# WEST WINDSOR TOWNSHIP

## MEMORANDUM

SUBJECT: **Princeton Executive Park**  
**Amended Final Major Site Plan – Phase 1 Hotel**  
**Amended Preliminary Site Plan – Phase 3 Restaurant**  
Block 9, Lot 12.01 and 12.011  
US Route 1 North, Meadow Road and Carnegie Center Drive  
**PB19-15-AM**

**SUBJECT:** Princeton Executive Park – formerly known as Roseland  
Planning Board Review Memorandum #1  
PB 19-15 Phase 1 (Hotel) and Phase 3 (Restaurant)  
Block 9, Lots 1.02 and 12.03; Block 9.03, Lot 12.02  
West Windsor Township, Mercer County, New Jersey

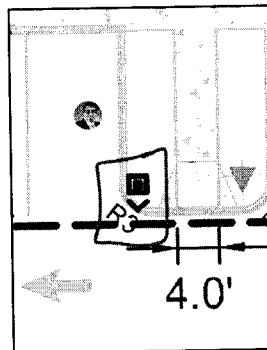
3. Electric Vehicle (EV) sign provided on Sheet 14A should be revised to match the MUTCD standard D9-11b as depicted below. Moreover, the EV pavement markings should also be presented on Sheet 4A and Sheet 4B as per PANYNJ standard.
